# Channel Law Group, LLP

September 3, 2022

**Re: C.F. Nos. 22-0922-S1 and 22-0922-S2; 650-676 S. San Vicente Blvd.;  
Case Nos. CPC-2017-467-GPA-VZC-HD-SPR-1A and VTT-74865-1A;  
ENV-2017-468-EIR (SCH No. 2020010172)**

1. *Parking Lifts Improperly Utilize Tandem Parking*

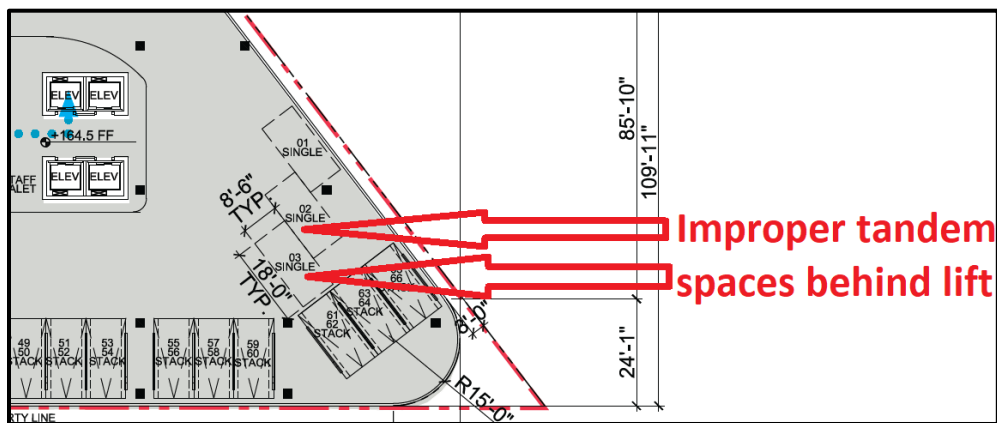
LAMC Section 12.21-A.4(h) requires that all required parking spaces shall be accessible. The Superintendent of Building has published the Parking Design Bulletin (**Exhibit 1**) to clarify the meaning of accessibility in the context of tandem and stacked parking.

## 2. Parking Lifts Fail to Provide Required Aisle Width

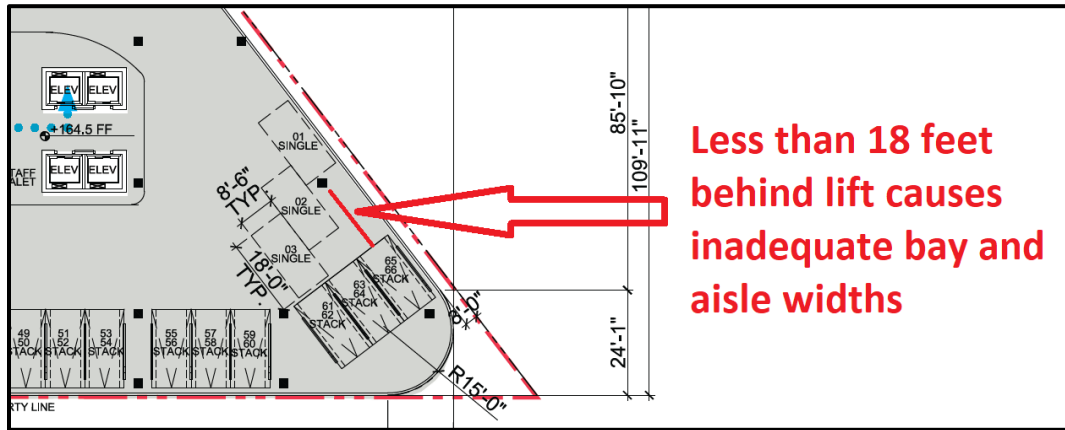
LAMC Section 12.21-A.5 establishes parking design standards, including graphs plotting minimum bay and aisle widths for parking areas based on the angle of parking. The LADBS Parking Design Bulletin clarifies the dimensions on these graphs to specify the precise widths required for various parking configurations. As noted above, the Parking Design Bulletin requires that the platform on the mechanical lift shall meet the standards in LAMC Sections 12.21-A.5(a) (Bay Dimensions) and 12.21-A.5(b) (Aisle Dimensions). Table 4 establishes minimum bay widths between 42 feet and 46 feet for standard parking stalls installed at 90 degrees to the aisle. Table 6 requires minimum aisle widths of 20' for compact commercial parking stalls and 22' for standard commercial parking stalls installed at 90 degrees to the aisle.

The Project fails to comply with these standards because parking lifts on the southern corner of the parking levels have inadequate bay and aisle widths. Based on the dimensions shown on the plans, the aisle width is less than 18 feet because there is a structural column located immediately behind the lifts. This results in a bay width of less than 36 feet, adding the 18 foot depth of each stall to the distance between the lift and the structural column, which is less than 18 feet. Thus, the lifts on each level are noncompliant with the LAMC and the parking spaces cannot count as required parking spaces. This noncompliance is illustrated below:

#### I. The Project's Driveway Locations Violate the LAMC

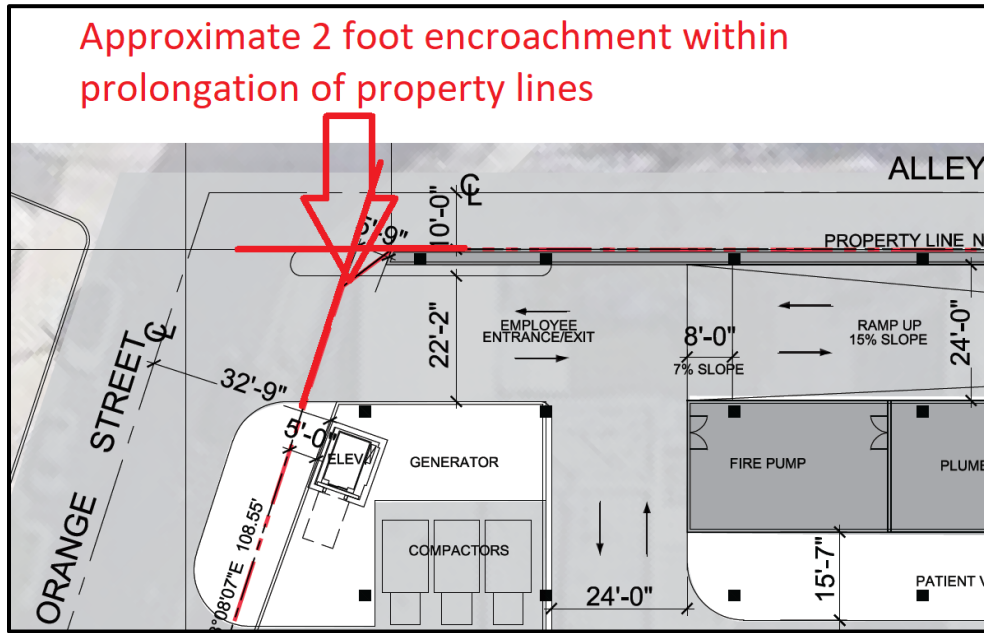
The LAMC prohibits the location of a driveway within a corner dedication. Section 62.105.1 provides:

Nor can this problem be resolved by locating the driveway further south on Orange Street, as LAMC Section 62.105.3 requires a minimum of 20 feet of curb space, excluding the curb return, between driveway approaches on the same street and serving the same lot. The Project's access and circulation plans conflict with basic site planning requirements establishing necessary dedications and driveway locations.
